Meeting Minutes

Missoula County
South Avenue Bridge Project

Subject:	Project TDC Meeting No. 05	Meeting Location:	HDR Engineering Inc. Office 700 SW Higgins Street, Suite 200 (Clark Fork Conference Room)
Meeting Date:	January 25, 2017; 12 PM (Mountain)	Conference Call Information	Call-in: n/a Code: n/a
Notes by:	Chris Kelly	Minutes Issued:	-

Conducted Technical Design Committee (TDC) meeting to review project and environmental document status, discuss traffic calming and aesthetics, and plan Public Meeting No. 3.

PROPOSED OPTION – CENTER ISLAND NARROWING

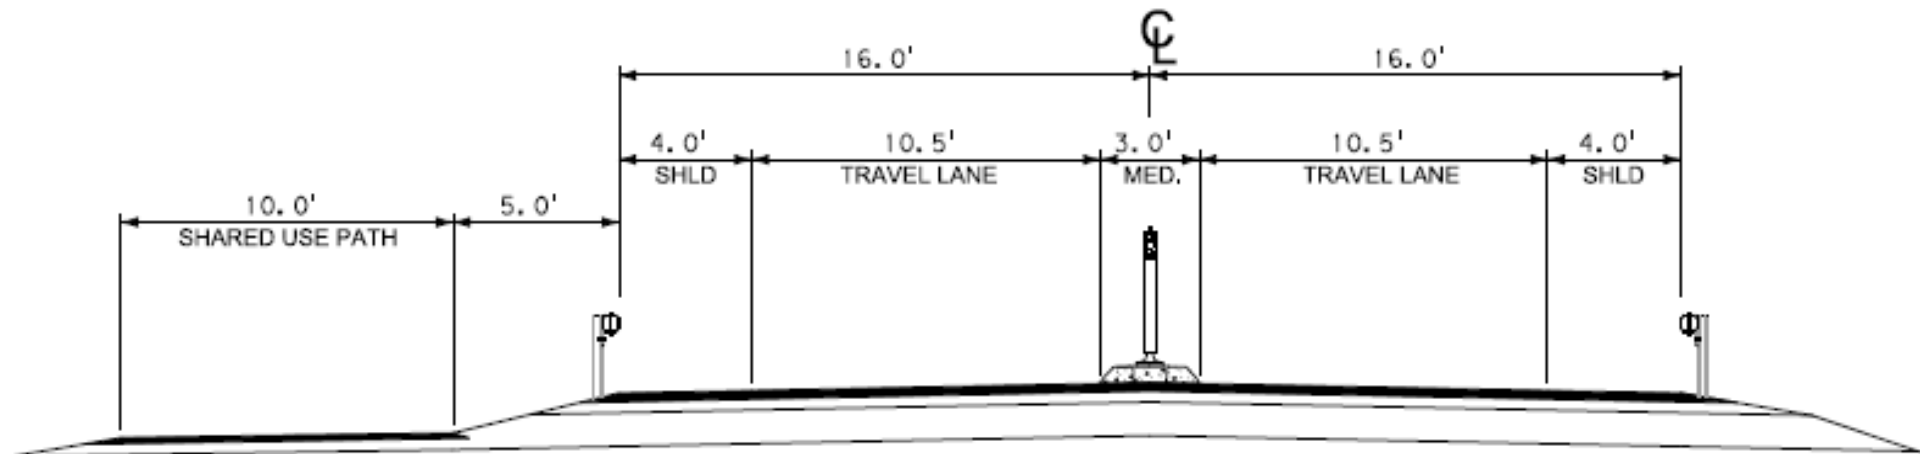
- Roadway narrowing with center median (proposed method).
- Currently showing a 3ft wide by 25' long median but could be widened to accommodate landscaping within it.

- Placement – proposing they be located on the east and west approach/end of bridge. Standard delineators would be placed on the ends, with the option to add additional signing.

- Easier for emergency vehicles, snow plows, etc. to navigate.
